WATERFORD 3 SES PLANT OPERATING MANUAL

EP-2-020
REVISION 7

Emergency Plan Implementing Procedure

Contaminated Injured/Ill Personnel

EOF FLOOR PLAN AND EQUIPMENT LOCATIONS

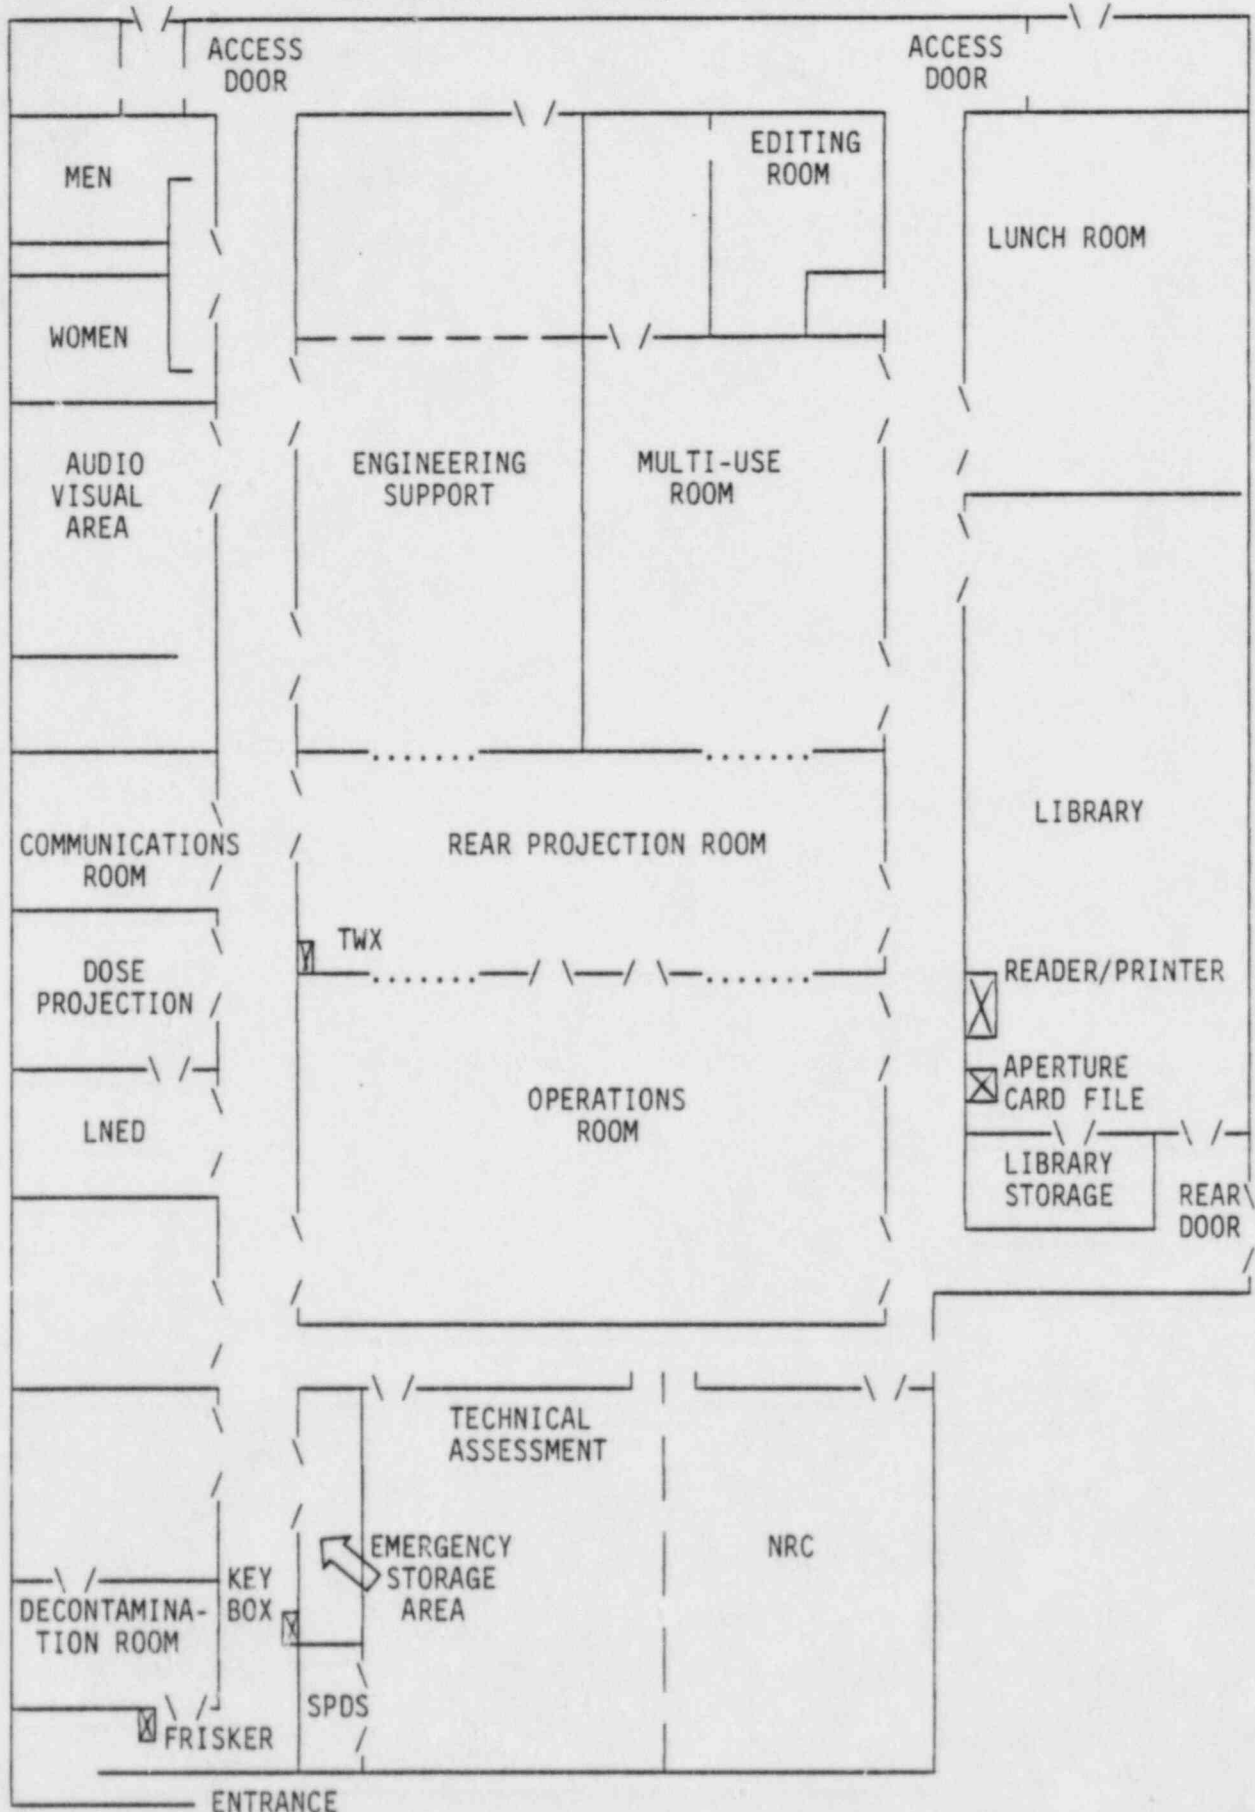
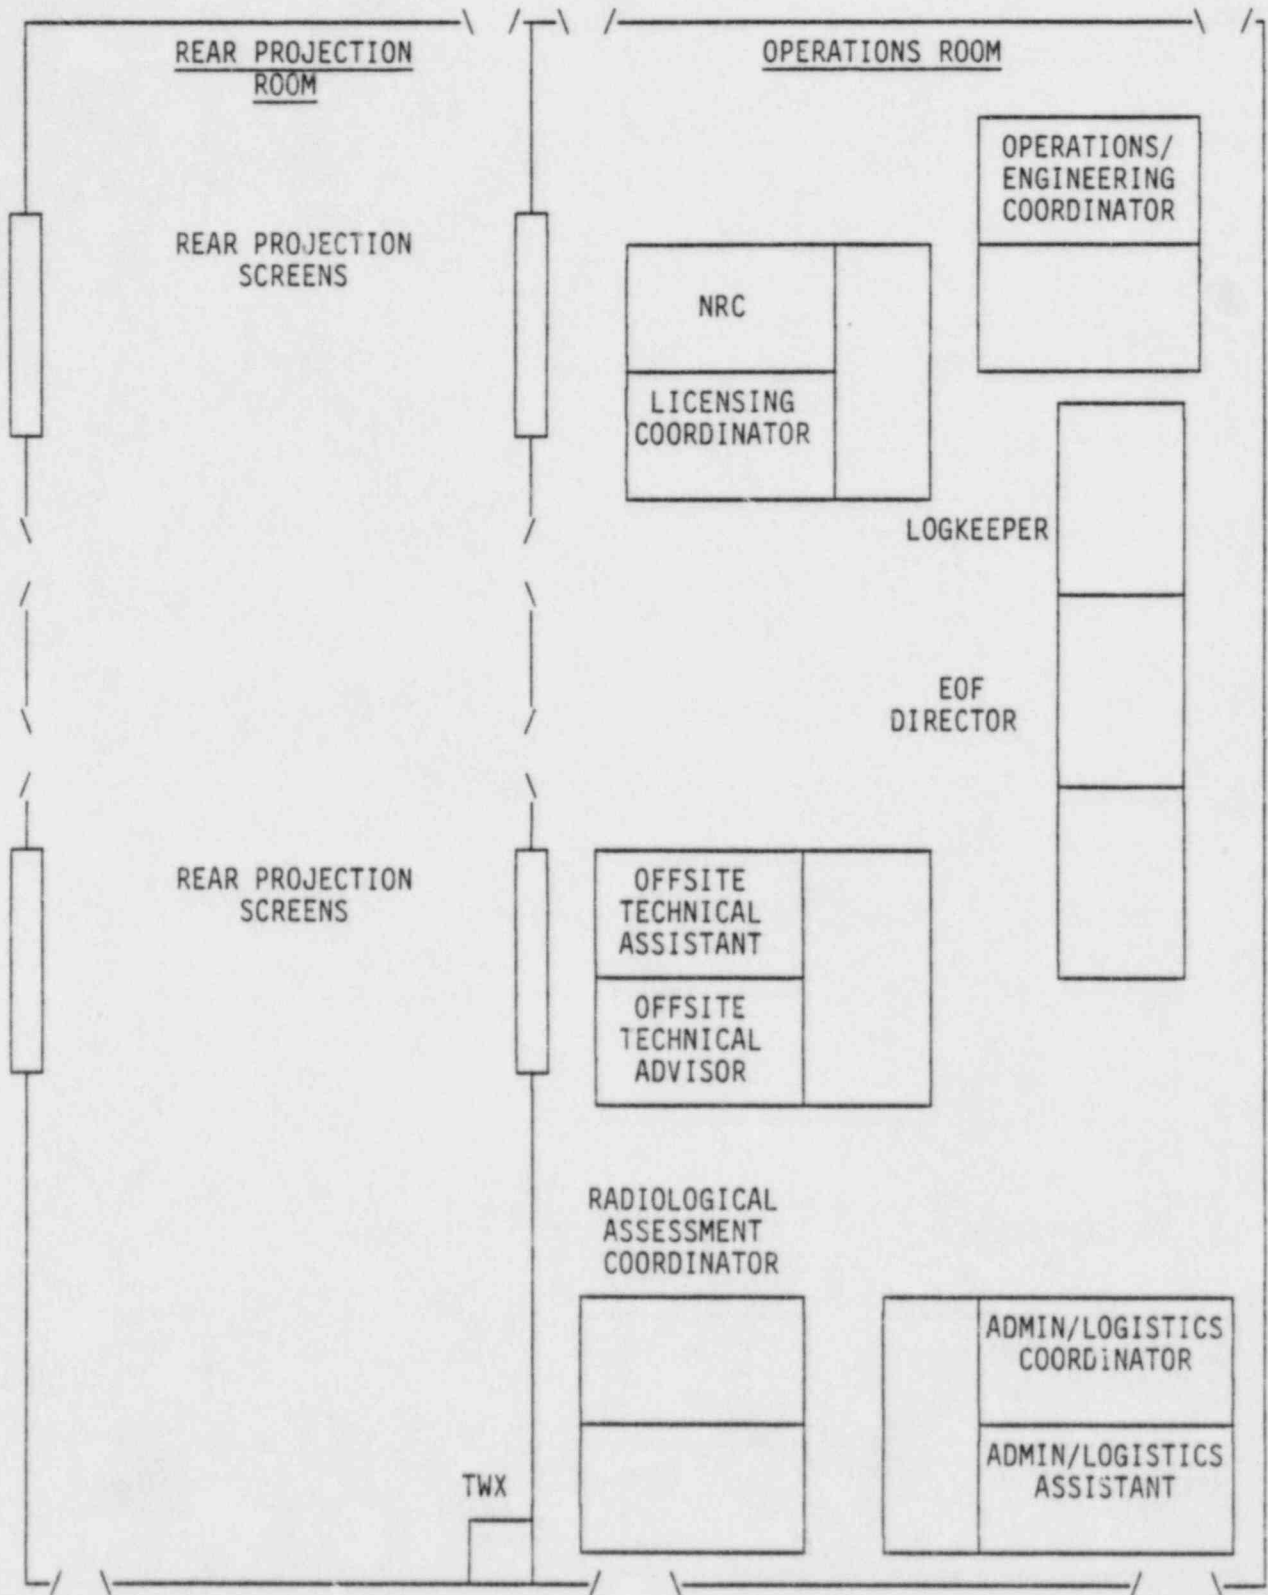
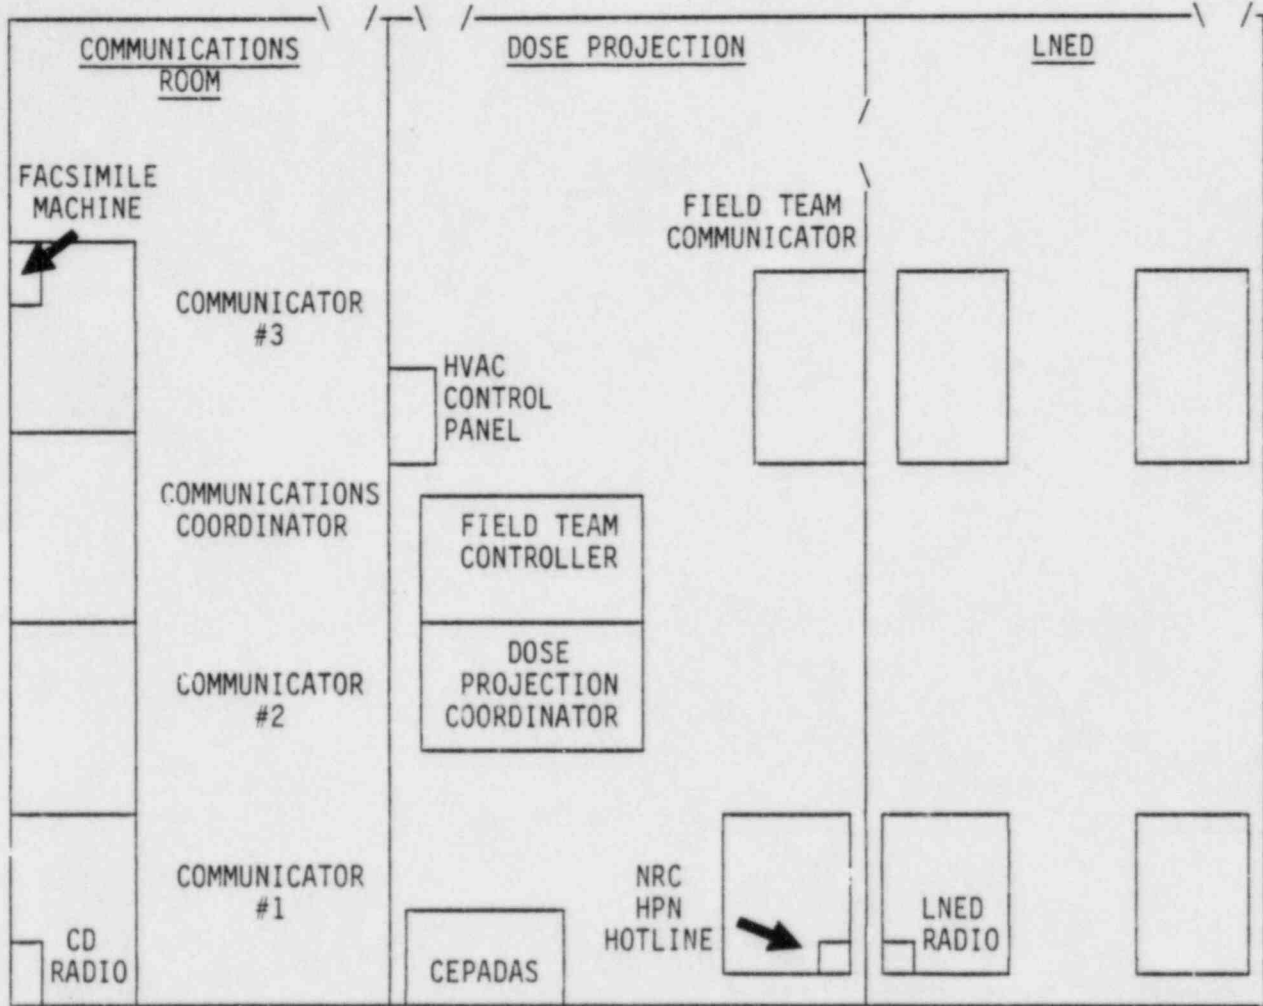
Change drawings, text and added attachment to reflect the new EOF layout and capabilities and design.
